**Planning, Development  
and Transportation**  
Transportation Planning  
305 Chestnut Street  
PO Box 1810  
Wilmington, NC 28402-1810

**DATE:** 10.20.2014  
**TO:** ProTrak  
**FROM:** Bill McDow  
Transportation Planning

■ **6020 OLEANDER DR OFFICE BUILDING [Initial Plan Review]**

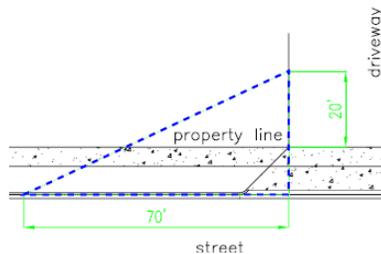
1. As the site driveway exceeds the corner clearance of 230' for lots along major thoroughfares as measured along the curb line; the applicant is requested to shift the proposed Oleander Drive driveway further away from the power pole at the NW corner of the site. The current driveway tapers are located at the minimum 6.5' from the adjacent property line.
2. Label the location/ type of storm water features within the proposed driveway aprons and ensure they are traffic rated.
